Executive Director's Recommendation

Commission Meeting: April 3, 2025

PROJECT Poplar Point Master Plan Washington, DC	NCPC FILE NUMBER MP317
SUBMITTED BY United States Department of the Interior, National Park Service	NCPC MAP FILE NUMBER 00:00(05.00)45996
REVIEW AUTHORITY Approval of Master Plans for use by the Commission per 40 U.S.C. § 8722(a) and (b)(1)	APPLICANT'S REQUEST Approval of comments on concept master plan
	PROPOSED ACTION Approve comments on concept master plan
	ACTION ITEM TYPE Staff Presentation

Poplar Point Master Plan

Alternative A: Greenway Connections

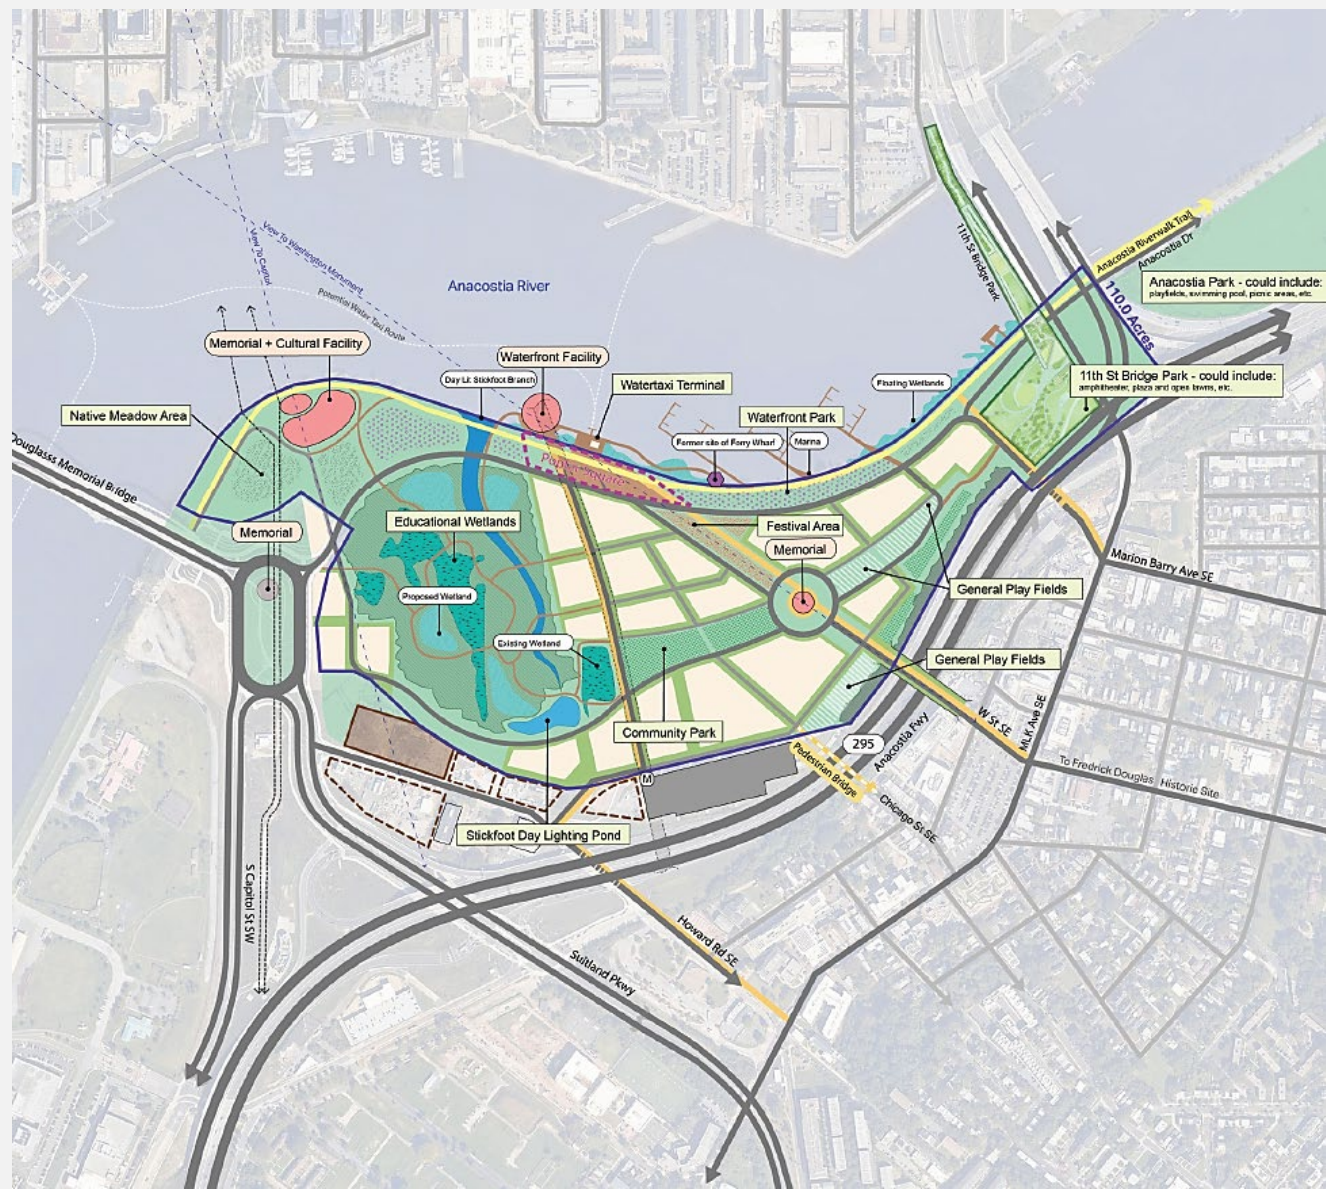
Supports the protection of views of the Capitol (New Jersey Avenue) and the Washington Monument, important viewsheds that add to the uniqueness of the site.

Supports the prominent locations identified for two future memorials, including one at the Point.

Supports the absence of development between the wetlands and the river which preserves expansive views and can allow for more natural hydrology.

Finds that the roadway design creates irregular shaped blocks and intersections that will need refinement as the plan progresses.

Finds the development pattern results in a potentially unpleasant green space between buildings and the I-295 freeway which is a space that may be better suited for development.

Alternative B: Central Wetlands

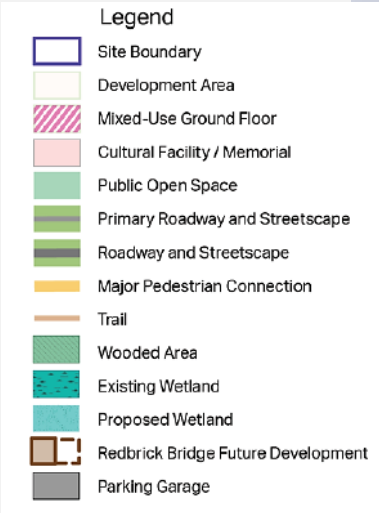
Finds Alternative B respects the viewshed to the Washington Monument, but not the New Jersey Avenue view to the U.S. Capitol.

Supports the prominent locations identified for the three future memorials.

Finds surrounding the wetlands with development limits views to and from the wetlands and reduces the opportunity for natural river flooding into the wetlands.

Finds the development pattern to the east is more efficient with smaller blocks allowing greater porosity and more usable areas for recreation.
